Memorandum from Community Development Engineering

TO: Hearings Examiner
 FROM: Anita Ashton
 DATE: July 7, 2022
 SUBJECT: SUB22-02 Hood Street

Responses to Olson Questions in Email Dated July 5, 2022:

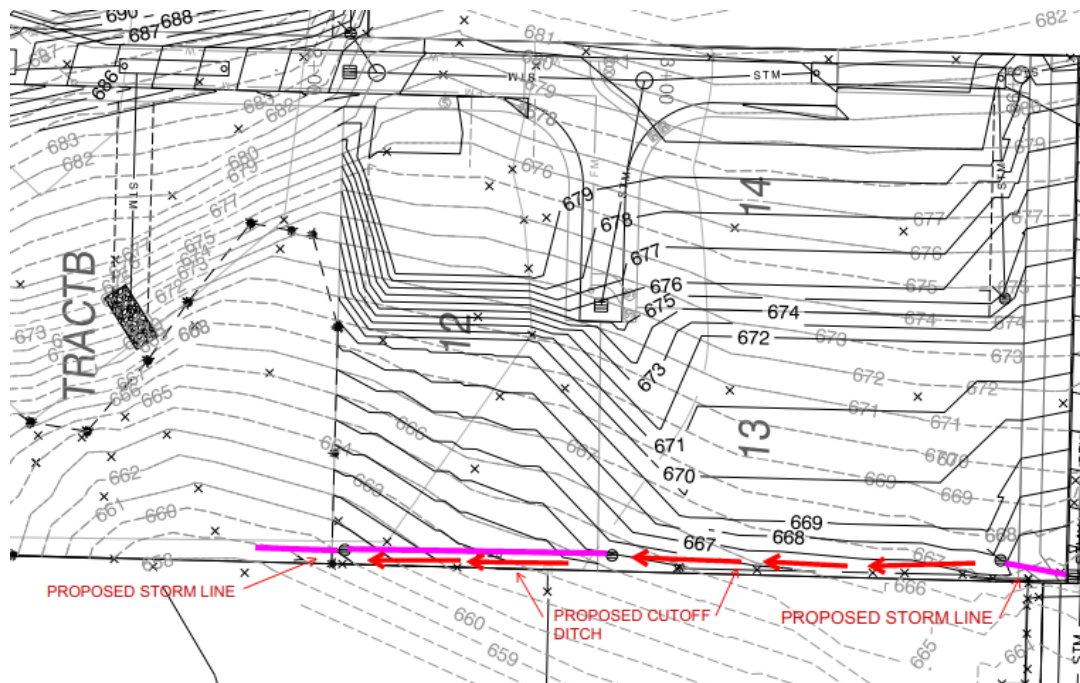
Regarding the drainage for lots 12 and 13 as shown below.

Since the wetland in Tract B falls away from Lot 12, no drain line is needed along the north boundary of Lot 12.

The land slopes to the west with potential runoff to adjacent lots to the west. To prevent this, a cutoff ditch is proposed along the west property line of both lots 12 and 13. In addition, a storm line will be installed along the west line of Lot 12 with catch basins installed in the NW corner of Lot 12 and Lot 13.

PRELIMINARY PLAT FOR:
HOOD ST. SUBDIVISION

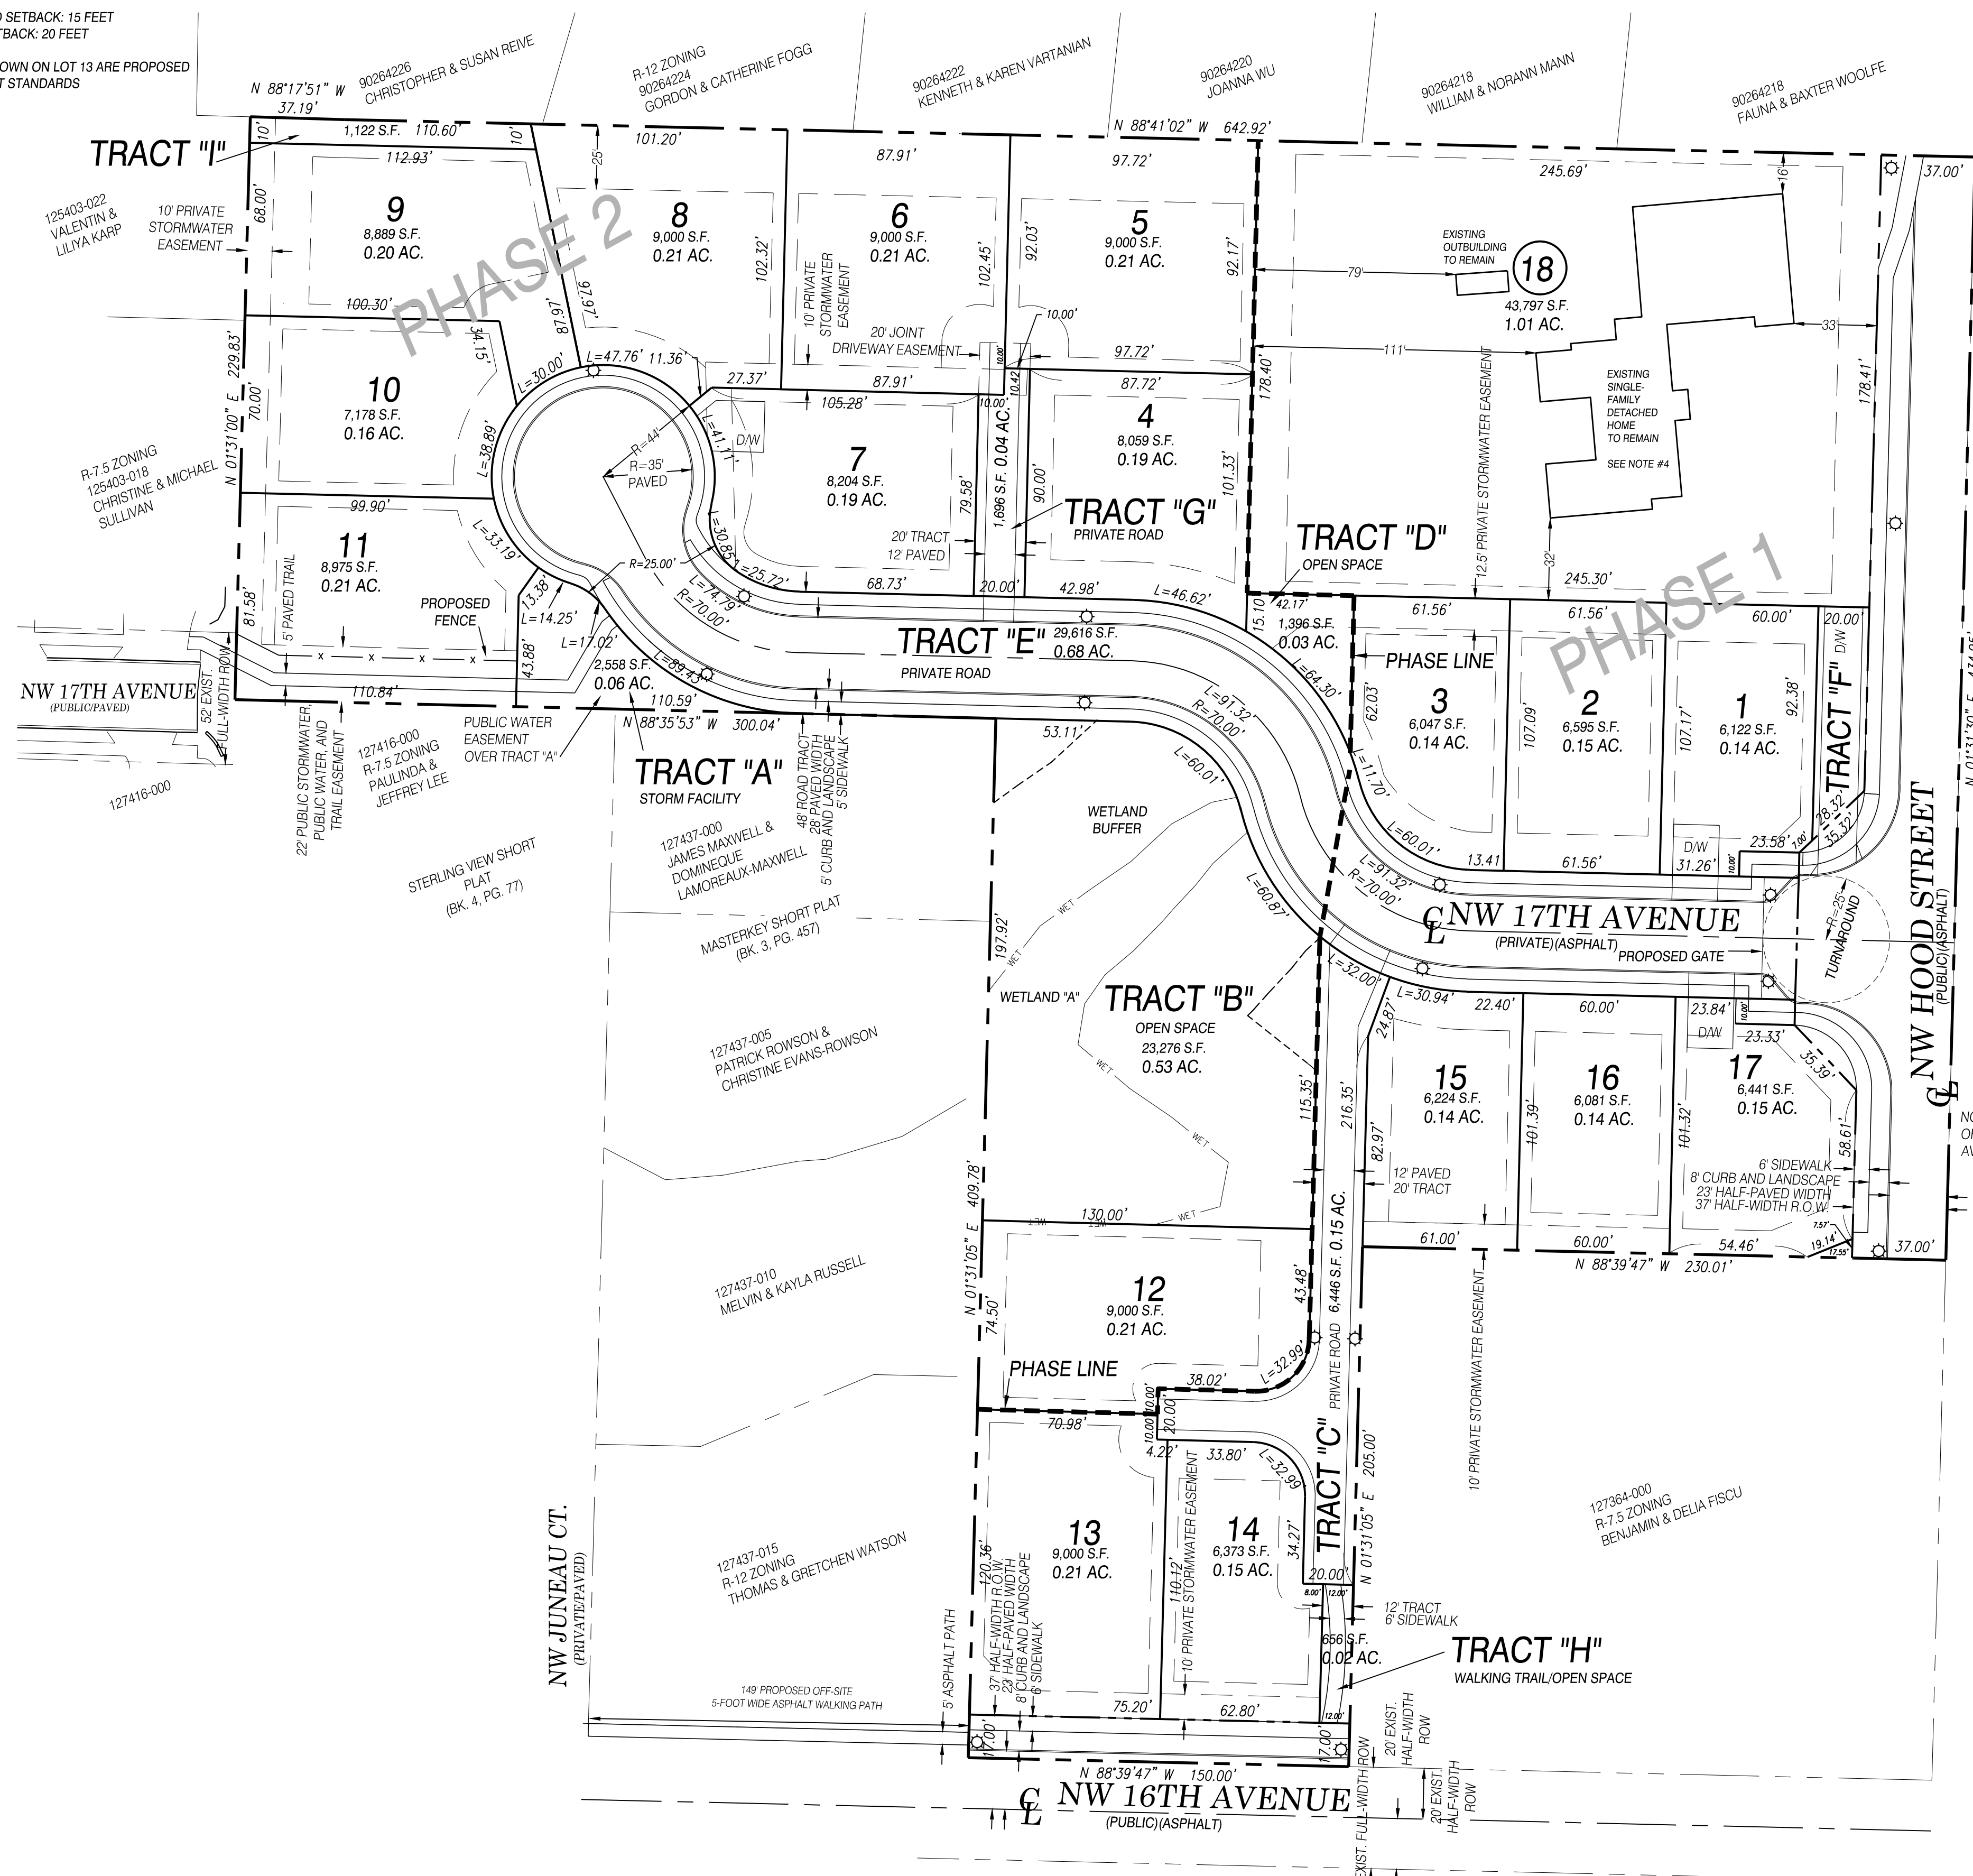
Staff Response: Discussion concerned a Tract vs. an Easement for the public pedestrian trail across Lot 11. The applicant submitted a revised preliminary plat, on July 7, 2022 that proposes a 22-foot wide easement over the southern portion of Lot 11, which will include the public pedestrian trail, the water main extension, the storm line, and a fence on the northern side of the easement; and thereby not impacting the size of Lot 11.

DESCRIPTION:	DATE:
REVISE SETBACKS FOR LOTS 5, 6, 8 AND 9.	7/22
REVISE LOTS 9, 10 AND 11.	
ADD TRACT "I".	
MODIFY EASEMENT ON LOT 11	
PER CITY OF CAMAS
